Re: Certification Submittal for Final Building Certificate of Occupancy for
Torrebiarte Office Bldg, [A-14 / D9D]
3730 Ellison Dr. NW
Architect's Stamp Dated 10/19/06

Re: TCL for Torrebiarte Office Building

QUARTERS PLAZA
OFFICE BUILDING
ENLARGED SITEPLAN
FOR BUILDING PERMIT

ENLARGED SITEPLAN

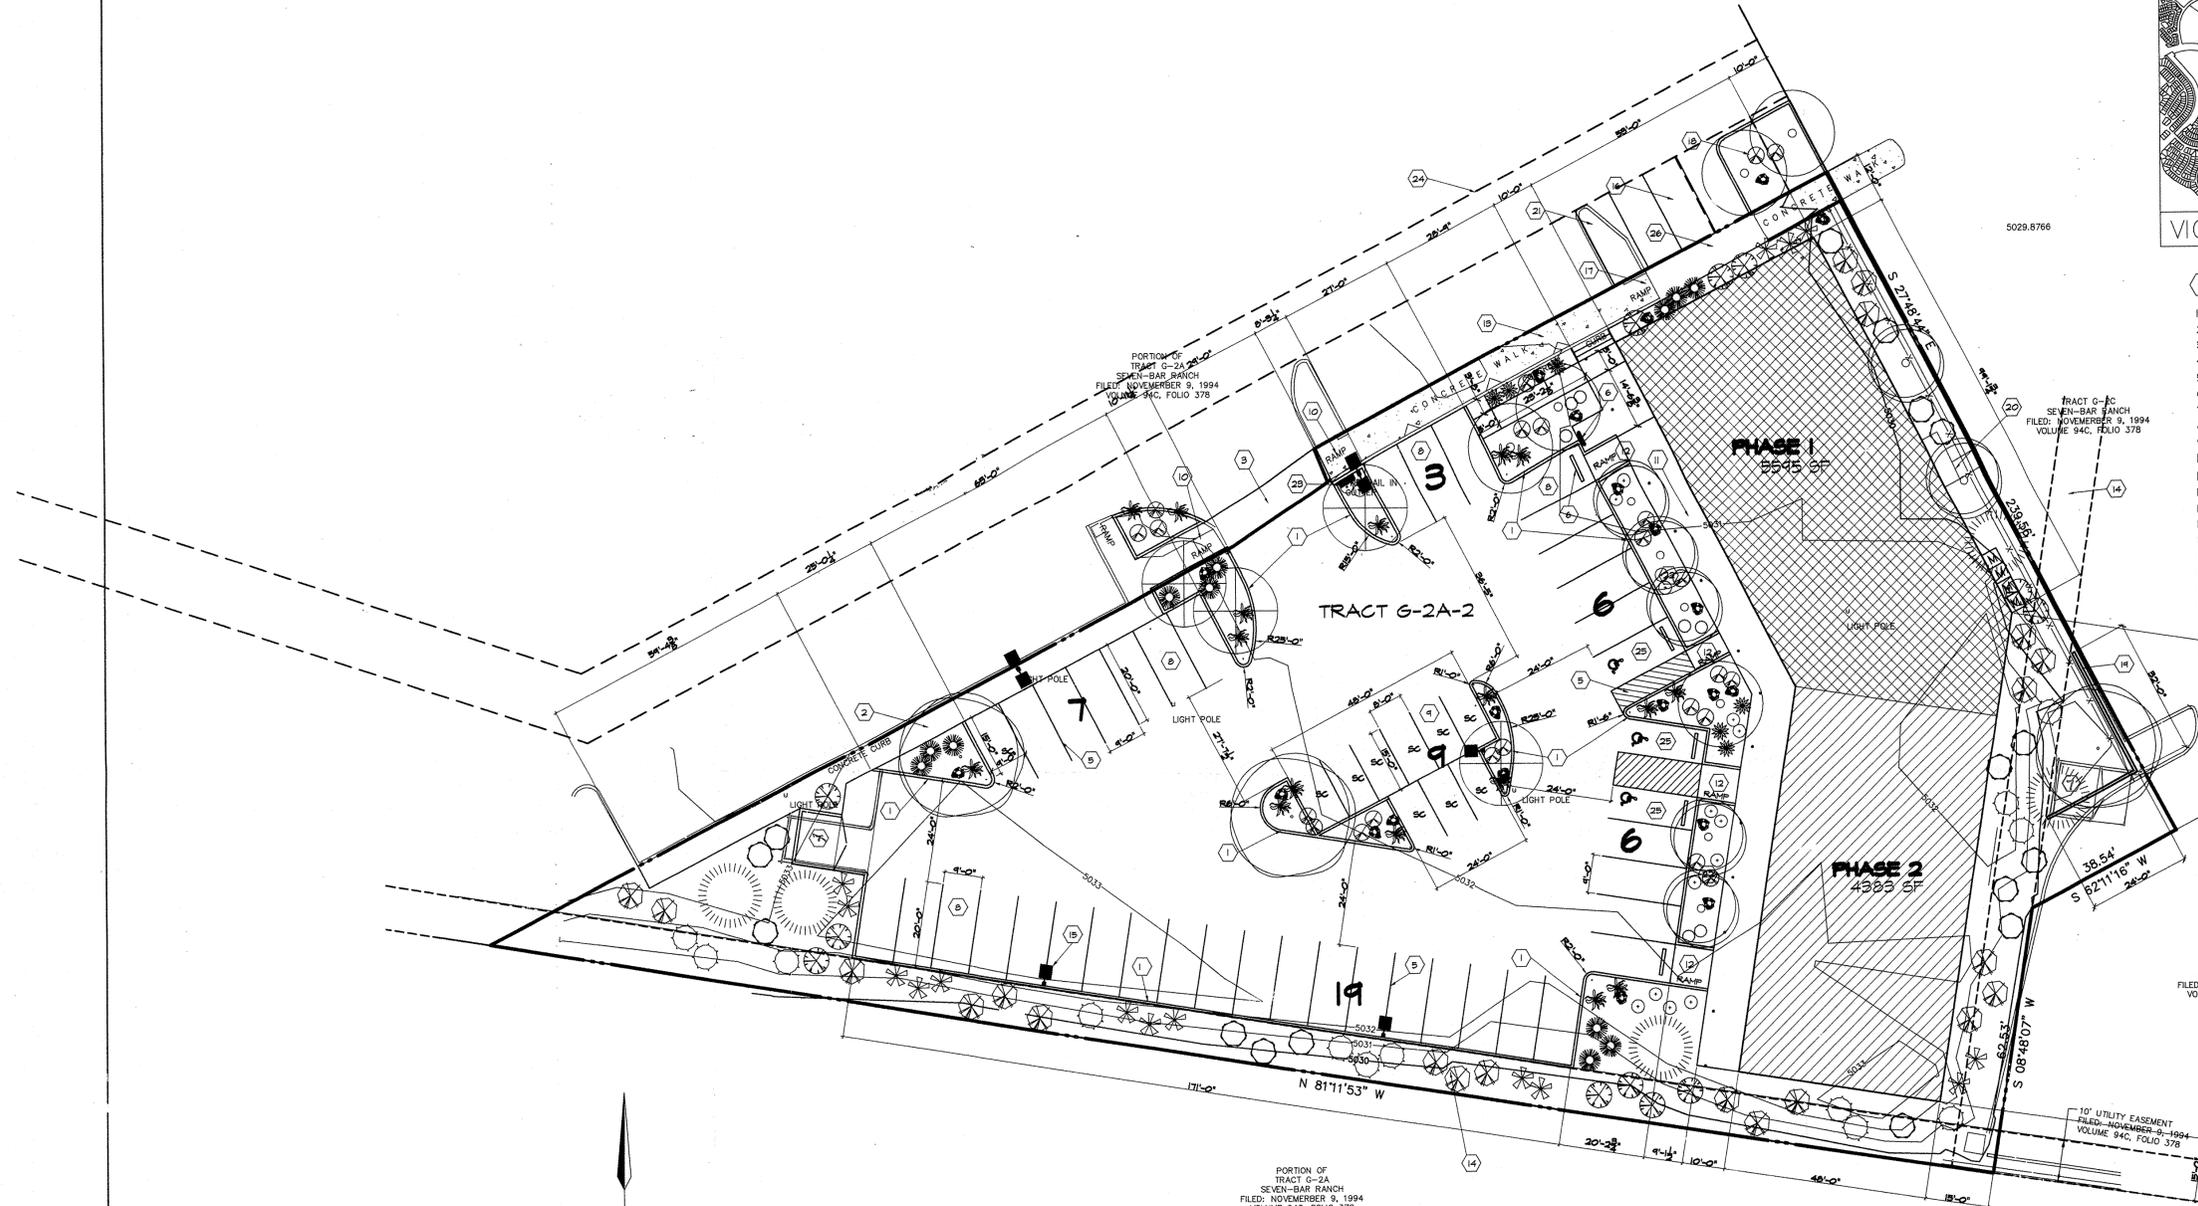
The refuge enclosure was moved to the eastern corner of the lot to consolidate the dumpsters after gaining approval from Michael Holton with Solid Waste Management. (See redlines on attached site plan.)
